5 Government submissions

This chapter provides a summary and response to the eight local and State government submissions (including interagencies) received on the proposed modification.

HVO South Modification 5

Response to submissions

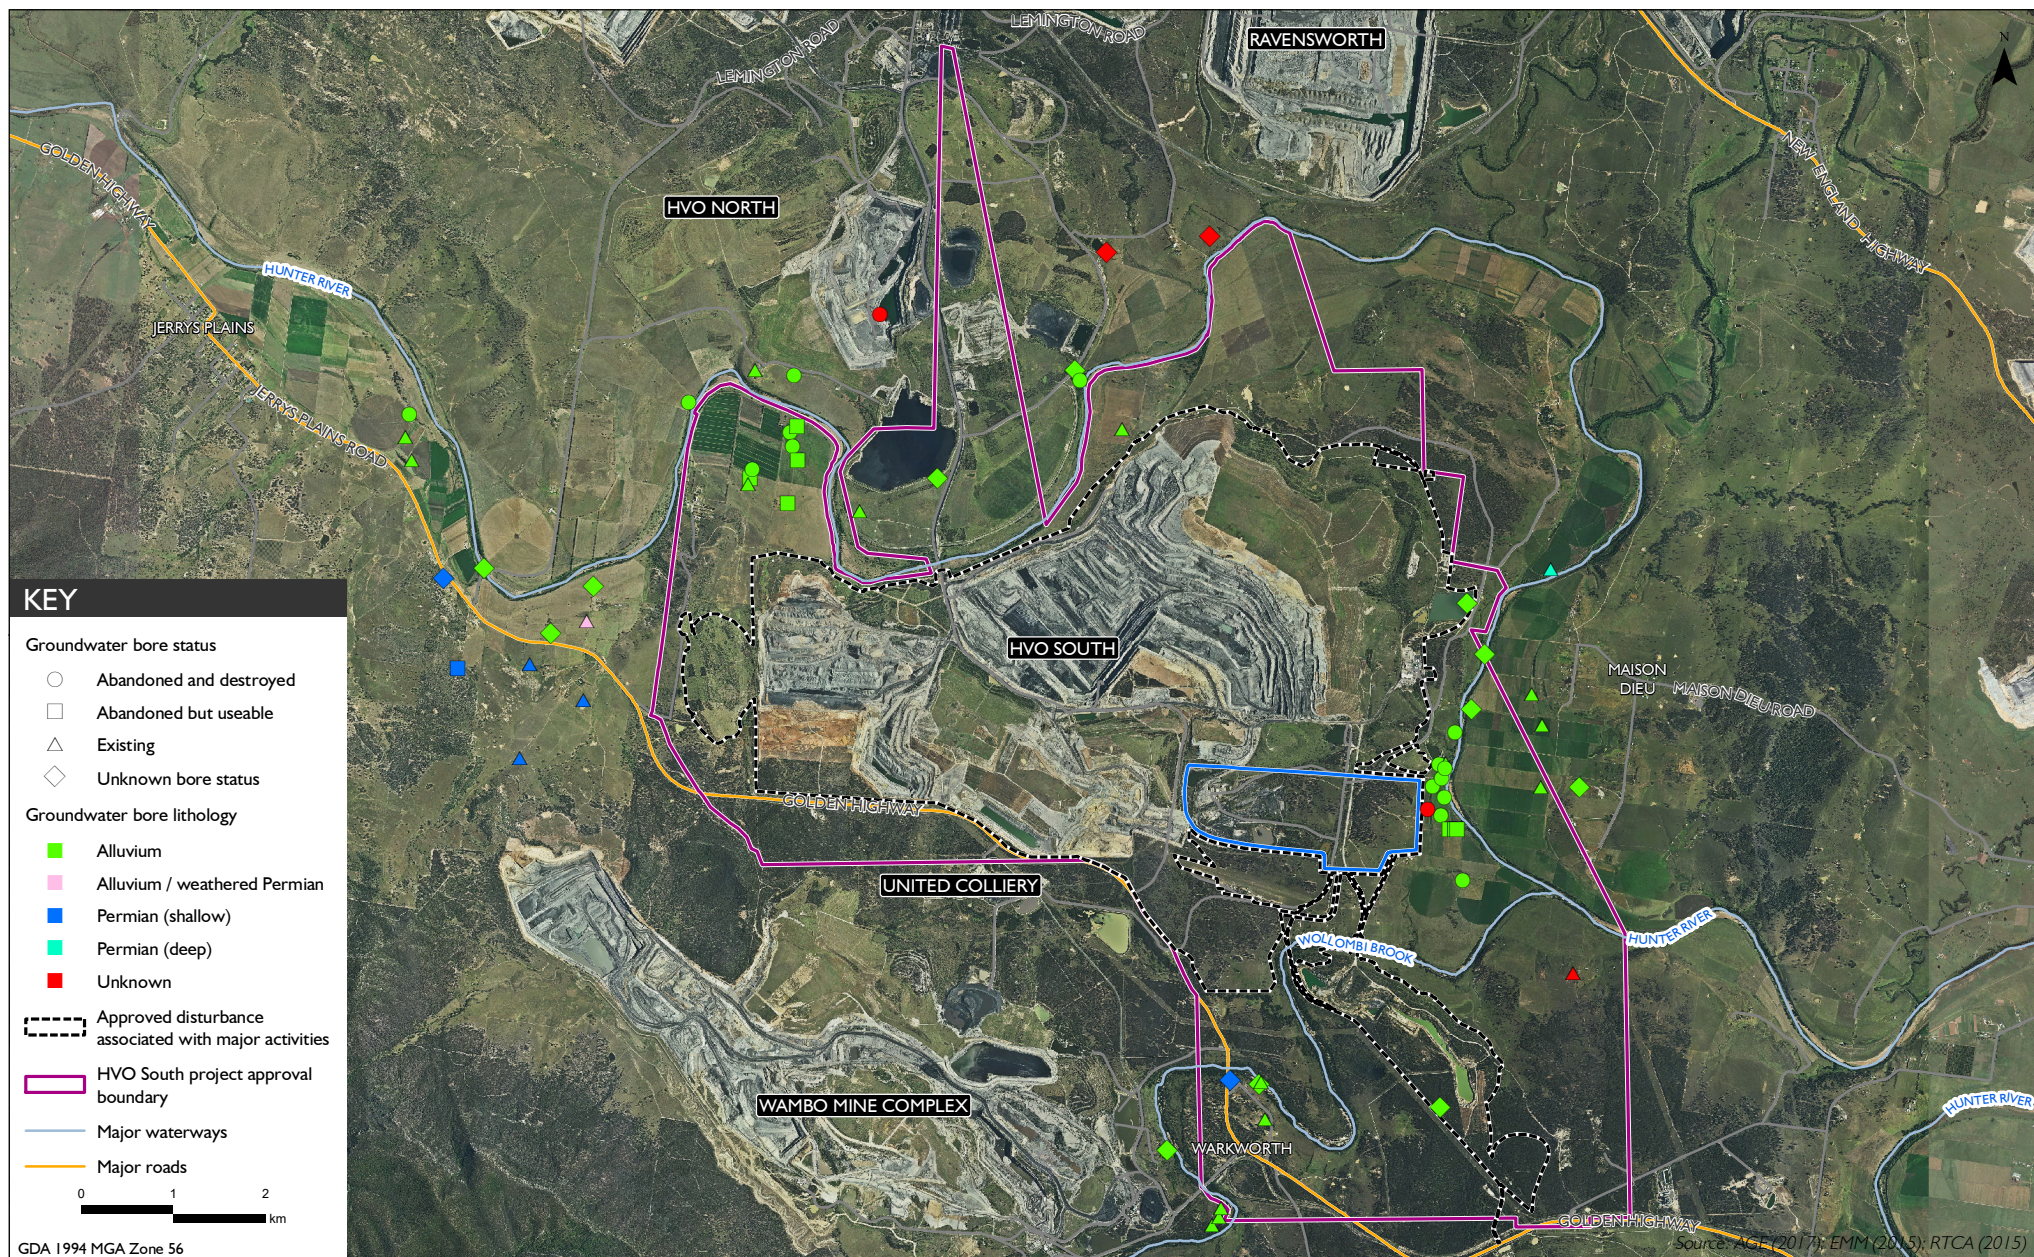
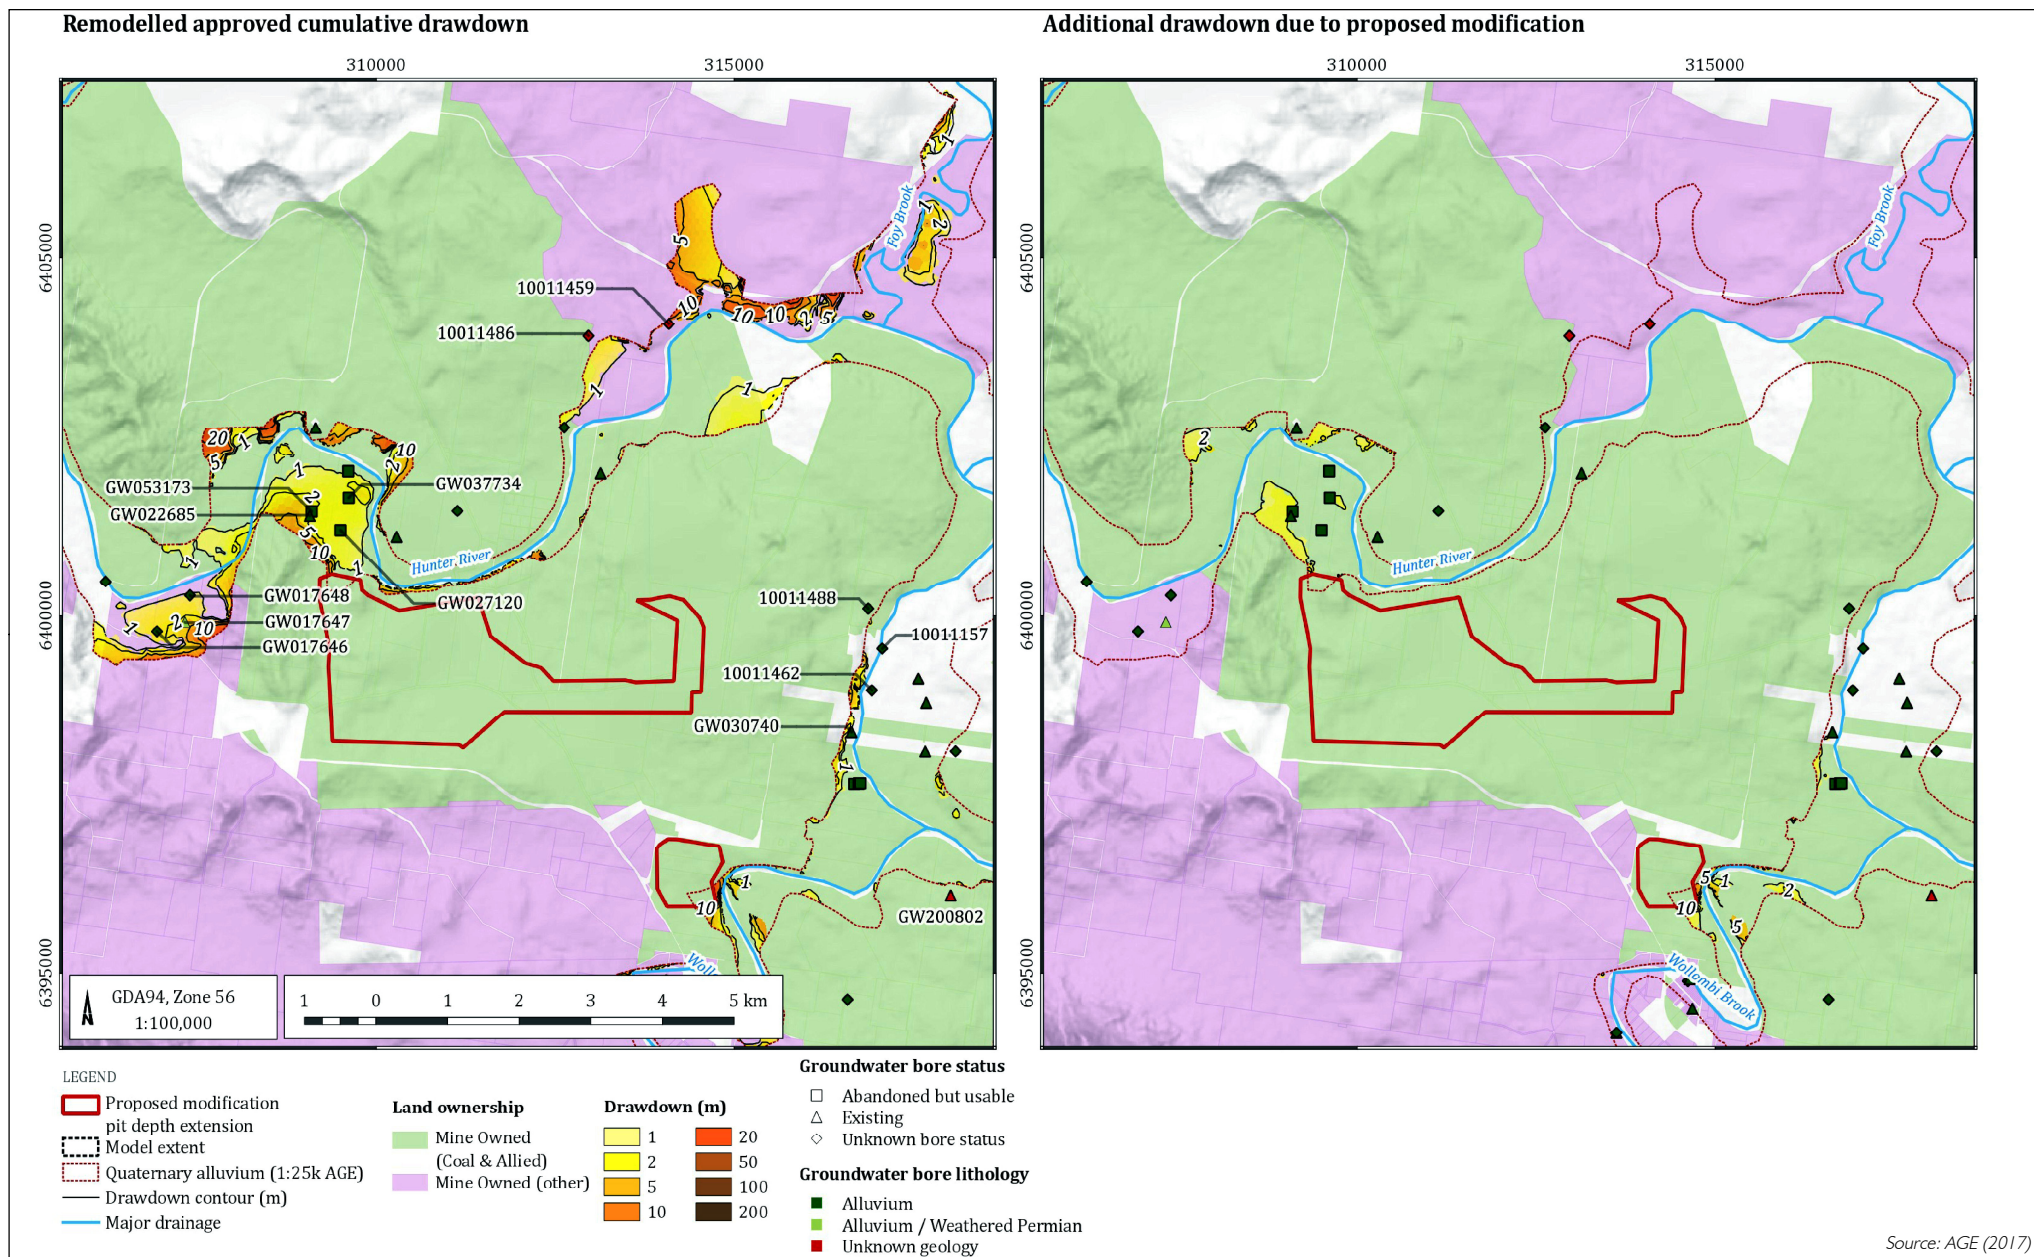
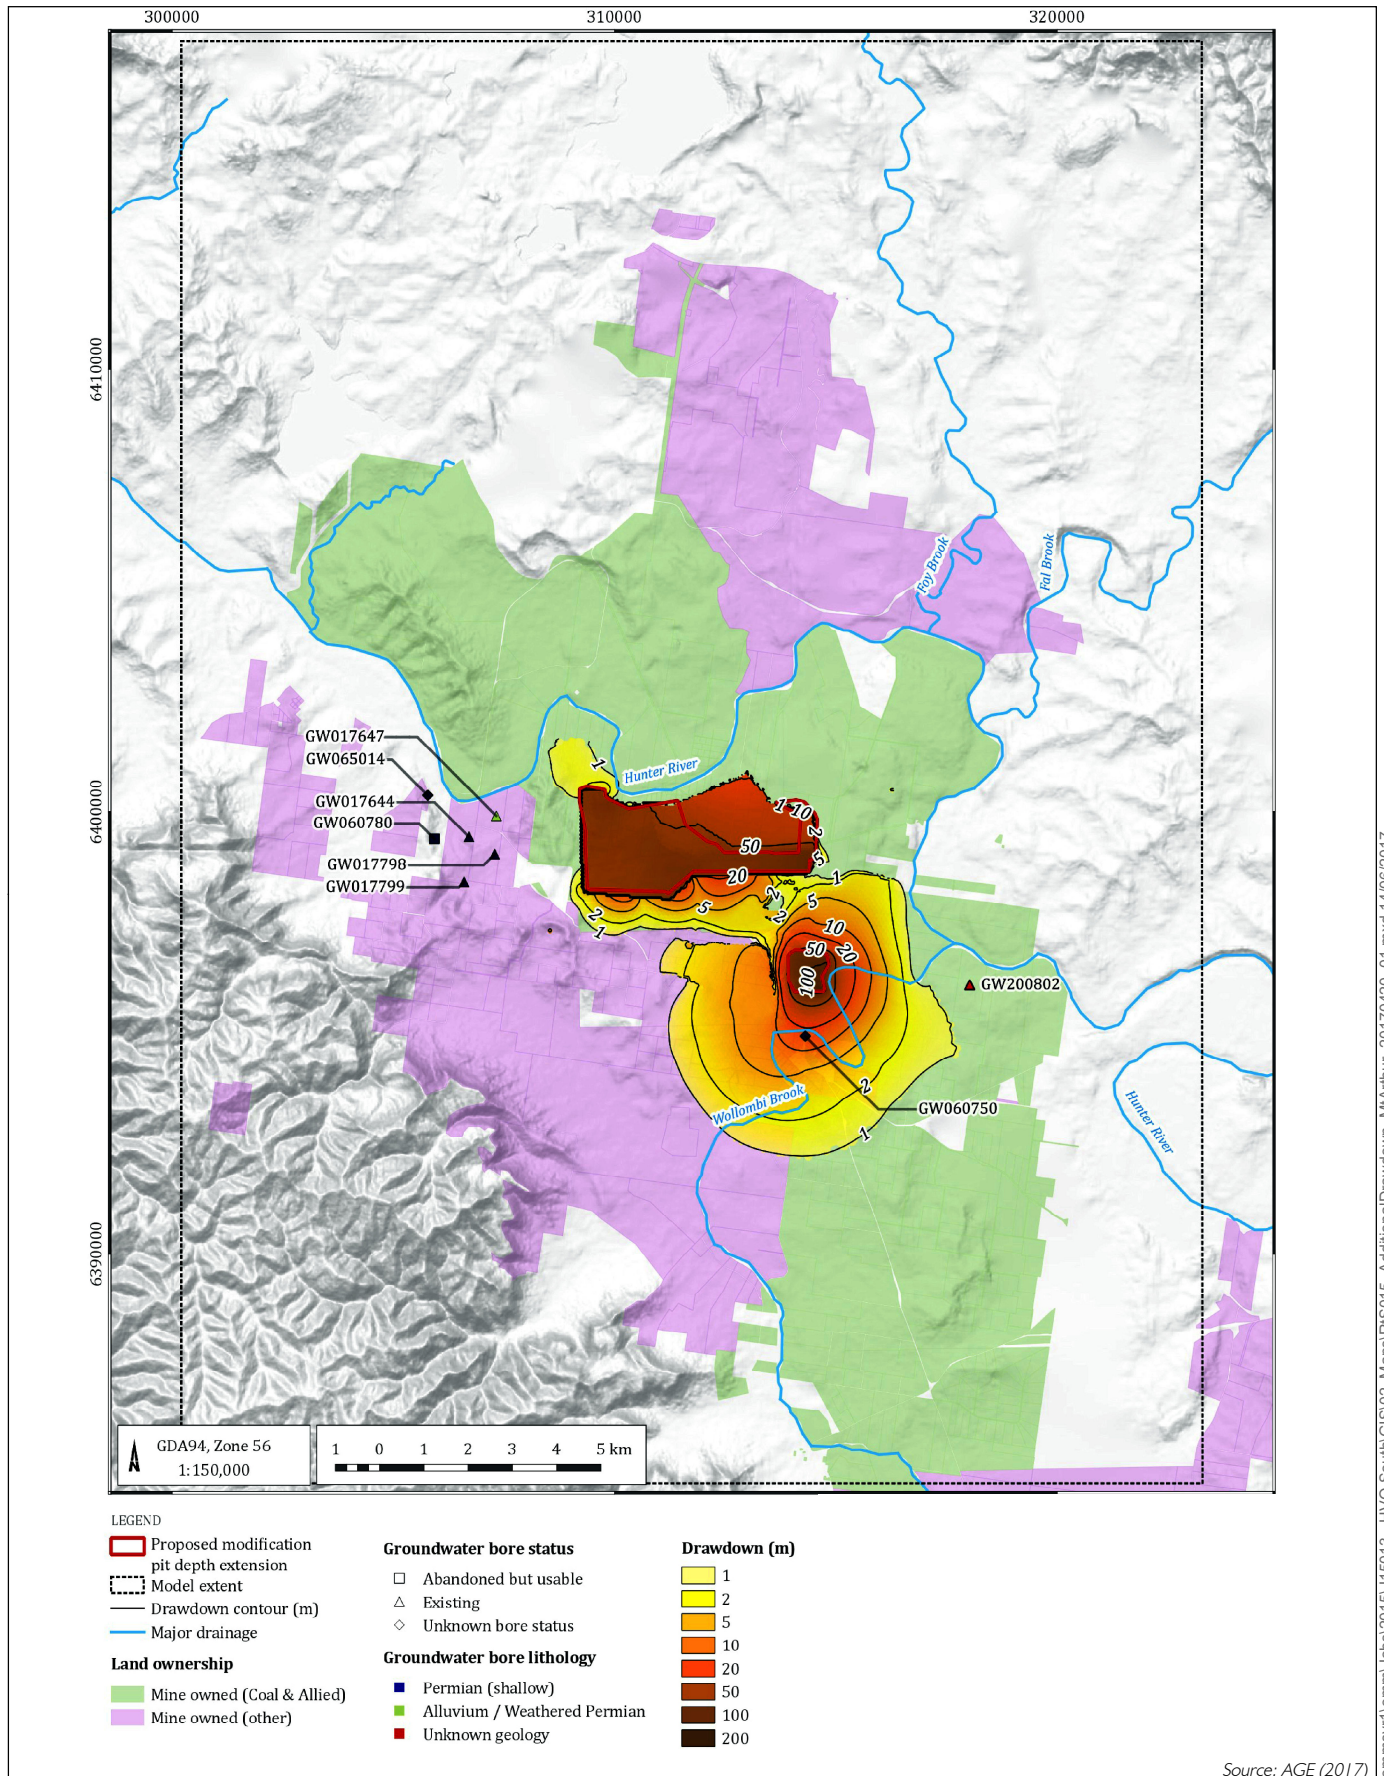
The DPI Water submission requested that Figure 10.3 of the EA (groundwater users) be updated to include all 43 bores surveyed, be colour coded to show different categories of bores and the target aquifers and include predicted drawdown contours. The submission also requested further information on the incremental drawdown on private extractors, including updating the relevant figures displaying drawdown to include surveyed bore and lithology details. These requests are addressed in the sections below.

Figures 5.5 to 5.7 present the predicted groundwater level drawdown in the Quaternary alluvium, shallow Permian coal measures (Mt Arthur Seam) and deeper Permian coal measures (Bayswater Seam) due to the proposed modification. Figures 5.8 to 5.10 present cumulative drawdown predictions for the three stratigraphic sequences. Each drawdown figure includes private bores that likely occur within the relevant lithology, which has been assessed based on available bore details (ie screened lithology and bore depth) and mapped geology. Full details about each private bore are in Table A-5 of the groundwater study within Appendix G of the EA.

As shown in Figures 5.5 to 5.7, groundwater level drawdown due to the proposed modification is largely restricted within the extent of land owned by Coal & Allied.

Figure 5.5 shows that no private bores will experience a drawdown due to the proposed modification within the alluvium in excess of 1m. As shown in Figure 5.8 and discussed in Chapter 10 of the EA and the technical study (Appendix G of the EA), there is one bore (10011459) on land owned by Glencore (Ravensworth Mine) with a bore depth of around 12m with predicted drawdown due to the proposed modification and with cumulative drawdown of greater than 2m. The decline is predominately due to the cumulative impact of the approved and surrounding operations, with the proposed modification only contributing 0.3m of additional drawdown.

Figure 5.18 Predicted annual average PM_{2.5} concentrations due to emissions from the proposed modification and other sources in Stage 2 (µg/m³)

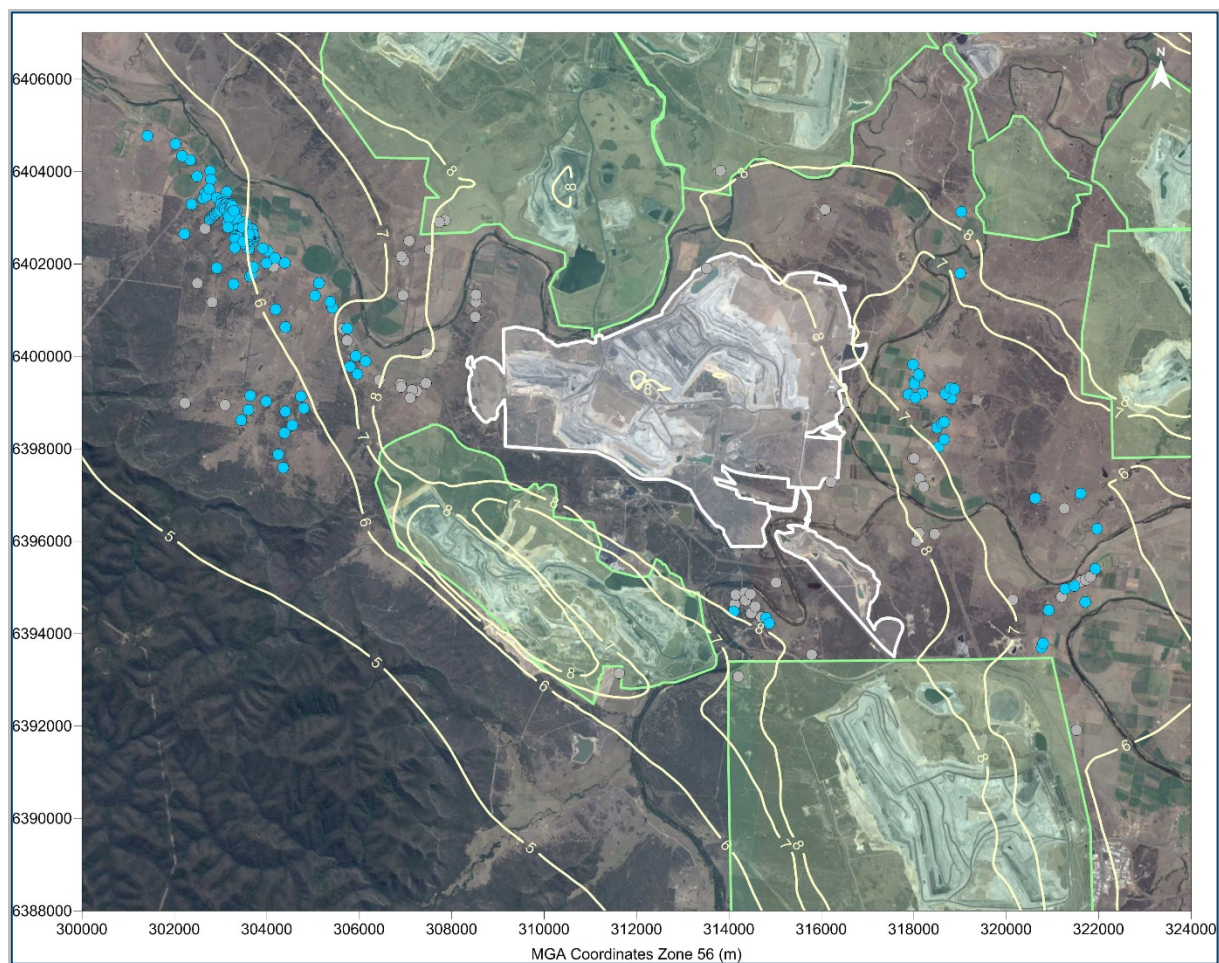
Hunter New England Population Health branch of the NSW Department of Health requested that the 7µg/m³ contour for annual average PM_{2.5} for Stage 2 and 3 be presented.

Figures 5.18 and 5.19 show isopleths including the 7µg/m³ value for the predicted annual average PM_{2.5} concentrations due to the proposed modification and other sources during the most active stages of the mining nearest residences, Stage 2 and Stage 3, respectively.
